SHATT AL ARAB SUBSTATION
BASRAH, IRAQ

SIGIR PA-05-009
MARCH 15, 2006

Shatt Al Arab Substation in Basrah, Iraq

Site Photo 2: 11 kV switchgear

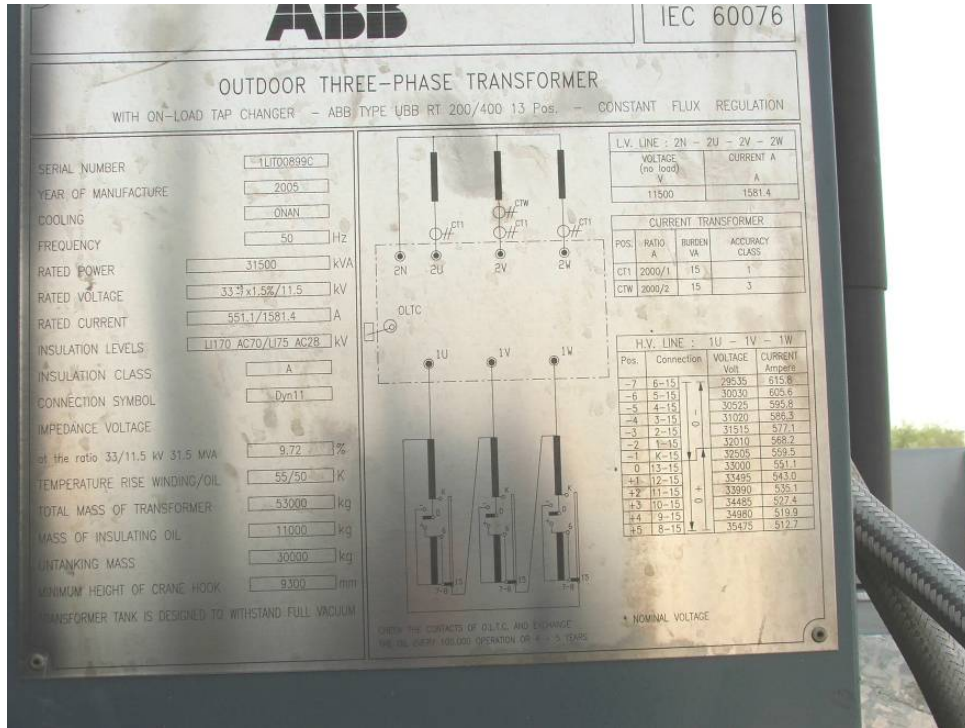
The contract and design required the purchase of an 11 kV switchgear and installation of the switchgear into the newly constructed substation building. The 90 % design and associated specifications required a 22 bay unit with switchboard rating of 12 kV, 2000A, and 31.5 kA x 3 seconds.

The on-site assessment verified the installation of the 11 kV switchgear. Details from the associated factory nameplate were not obtained during the site assessment; however, the equipment and installation appeared to be consistent with the contract, design, and specifications. Site photo 2 shows the 11 kV switchgear located inside the substation building.

Site Photo 4: Factory nameplate of on-load TAP changer

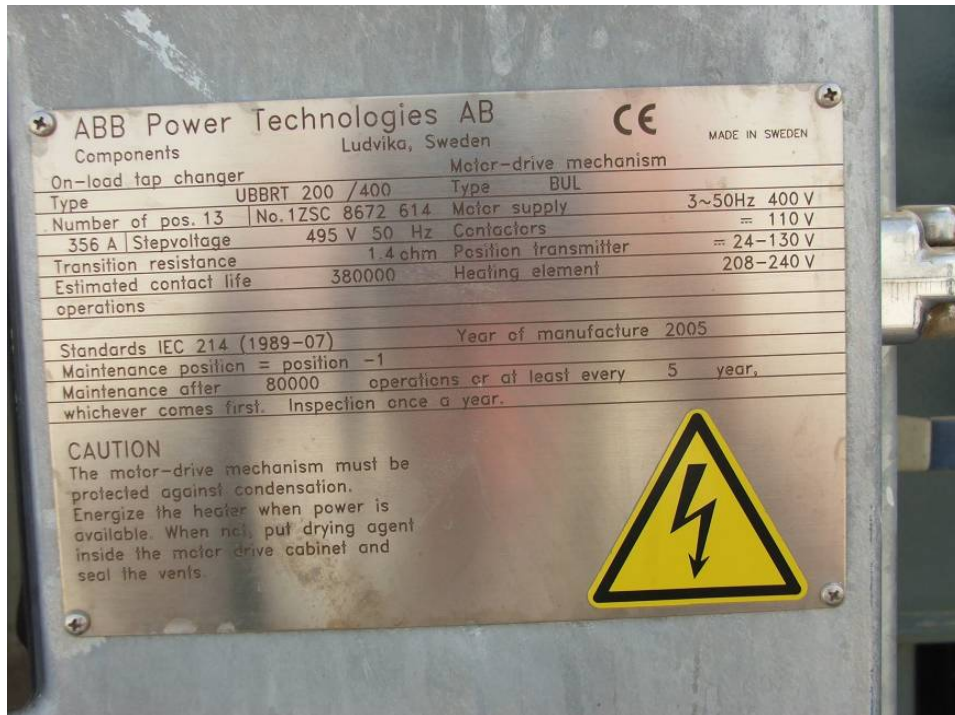
The on-site assessment verified the installation of two 33 kV to 11kV transformers on concrete pads with firewalls between the two transformers. The associated factory nameplates list the transformers as outdoor three phase transformers with on-load TAP changer – type UBB RT 200/400 13 Pos. – constant flux regulation. The listed ratings are: frequency 50 hertz (Hz), rated power 31500 kV, rated voltage 33 (+5,-7) x 1.5%/11.5 kV, and current 551.0/1581.4 A. The serial numbers are 1LIT00899C and 1LIT00899D. The on-load tap changer nameplate lists the company name as ABB Power Technologies AB, type UBBRT 200/400, and serial numbers 1ZSC 8672 614 and 1ZSC 8672 617.

The equipment and installation appeared to be consistent with the contract, design, and specifications. Site photo 3 shows the factory nameplate of one of the two 33 kV to 11 kV transformers. Site photo 4 shows the factory nameplate of one of the two on-load TAP changers.

Site Photo 5: 11 kV to 0.4 kV transformer

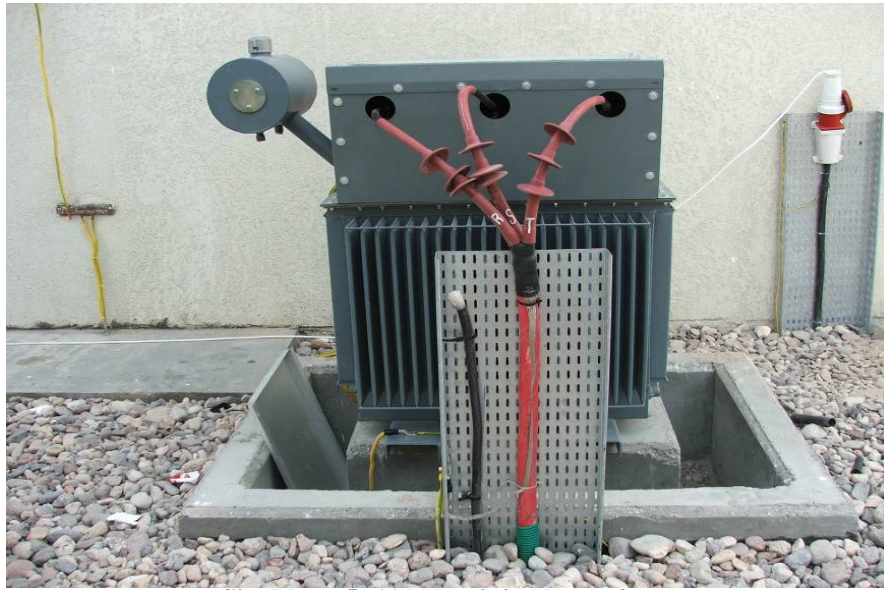
The on-site assessment verified the installation of two 11 kV to 0.4 kV transformers on concrete pads. The associated factory nameplate lists the transformers as a three phase Newton Poggibonsi 250 kV 50 Hz unit. Nominal Voltage for primary is listed at 11 +/- 2x2.5% kV and for secondary is listed at 0.41 kV. Nominal Current is listed at 13.1 A for the primary and 352 A for the secondary. Transformer serial numbers for the two units are 14761 and 14762.

Site photo 5 shows one of the two installed 11 kV to 0.4 kV auxiliary transformers. Site photo 6 shows the associated factory nameplate. The equipment and installation appeared to be consistent with the contract, design, and specifications.
